Subject: MHI's Responses to US-APWR DCD RAI No. 151-1824 Revision 1

Responses to Request for Additional Information No. 151-1824
Revision 1

RAI NO.: NO.151-1824 REVISION 1
SRP SECTION: 19 – Probabilistic Risk Assessment and Severe Accident Evaluation
APPLICATION SECTION: 19.1
DATE OF RAI ISSUE: 1/12/2009

Figure 1 Instantaneous CDF_{total} and LRF_{total} profile of case 1

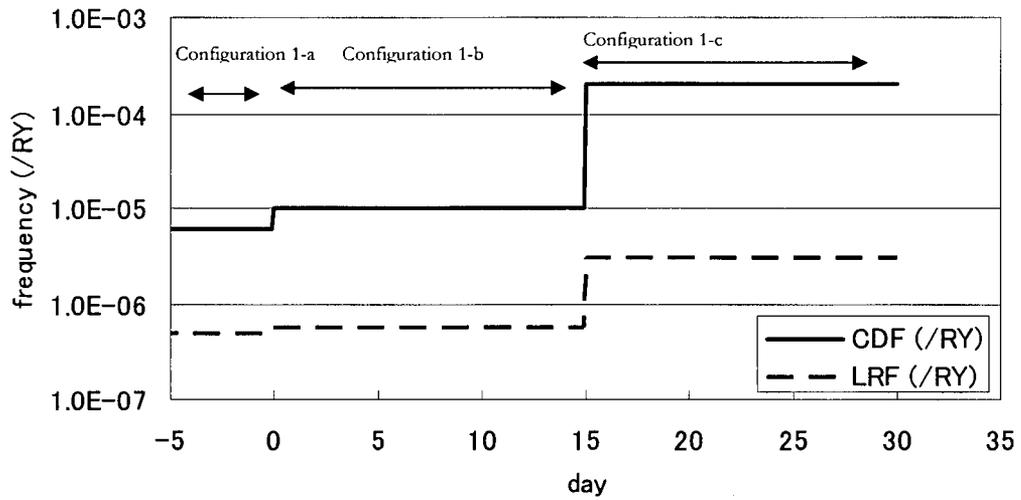
QUESTION NO. : 19-288

In Section 19.1.7.6 of the US-APWR design control document (DCD) it is stated: "At the design stage, PRA results have been used as input in the development of the technical specifications (Chapter 16). PRA insights are utilized to develop risk-managed technical specifications (RMTS) and surveillance frequency control program (SFCP)." Please discuss in more detail (e.g., by providing a few examples) how the PRA results were used at the design stage in the development of TS. In addition, for demonstration purposes, please include at least one example of using the US-APWR PRA to apply the RMTS guidance (NEI 06-09). The terms LERF (large early release frequency) and ILERP (incremental large early release probability) in the NRC- approved NEI guidance can be substituted with the terms LRF (large release frequency) and ILRP (incremental large release probability) used in the US-APWR PRA. The selected example(s) should be realistic but "challenge" the process with respect to PRA key assumptions, the use of insights from external events, and the presence of uncertainties. A good example for implementing NEI 06-09 could be the following: While the plant operates at power with one emergency ac power gas turbine generator (GTG), one alternate ac (AAC) GTG, and one turbine-driven (T-D) emergency feedwater (EFW) pump out for preventive maintenance, one of the two motor-driven (M-D) EFW pumps is found to be inoperable. Suppose that neither one of the M-D or the T-D pumps can be returned to service within the required completion time (CT) and NEI 06-09 guidance is used to extend the CT. While the plant is at power in the above described configuration within the extended CT, HVAC is lost to the room where the remaining M-D EFW pump is located. Please provide results showing the ICDP and ILRP values versus time. In your discussion, include (1) specific compensatory risk management actions that may be credited in the calculations, (2) key modeling assumptions that are important to ensure that the RMTS decision-making process is robust, and (3) any important assumptions made in the external events calculations and how it is determined that the PRA models for internal fires and flooding ensure reliable or bounding results consistent with NEI guidance and, thus, suitable for use in the RMTS decision-making process.

Configuration 1-a : The plant is operating at power with Class 1 GTG of train C, AAC of train B, and SIP of train C out for preventive maintenance. In this configuration all of the systems meet its LCOs. The CDF and LRF for internal events during this plant configuration are $2.0E-6$ /RY and $1.7E-7$ /RY, respectively. CDF_{total} and LRF_{total} are $6.0E-6$ /RY and $5.0E-7$ /RY, respectively.

Configuration 1-b : At time = 0 day, SIP of train B is found to be inoperable. Two trains of the safety injection system (SIS) are now out of service and LCO 3.5.2 is not met. The CDF and LRF for internal events during this plant configuration are $3.3E-6$ /RY and $1.8E-7$ /RY, respectively. CDF_{total} and LRF_{total} are $9.9E-6$ /RY and $5.5E-7$ /RY, respectively. Neither of the SIP can be returned to service within the front stop CT and RICT is applied. The calculated RICT is 551 days according to ICDP and 1298 days according to ILRP. The 30 day backstop is applied.

Configuration 1-c : At time = 15 day, SIP train D is found to be inoperable. Three trains of the SIS are out of service. The CDF and LRF for internal events during this plant configuration are $6.8E-6$ /RY and $2.7E-7$ /RY, respectively. CDF_{total} and LRF_{total} are $2.0E-4$ /RY and $3.1E-6$ /RY, respectively. The RICT is recalculated based on the new plant configuration. The calculated RICT is 33 days according to ICDP and 143 days according to ILRP. The 30 day backstop remains.

Instantaneous CDF and LRF profile of case 1 is shown in figure 1. ICDP evolution of case 1 is shown in figure 2.

- Calculated RICT for case 1 exceeds 30days. The 30 day backstop is applied and the ICDP as well as ILRP from outages are maintained below the acceptance criteria.
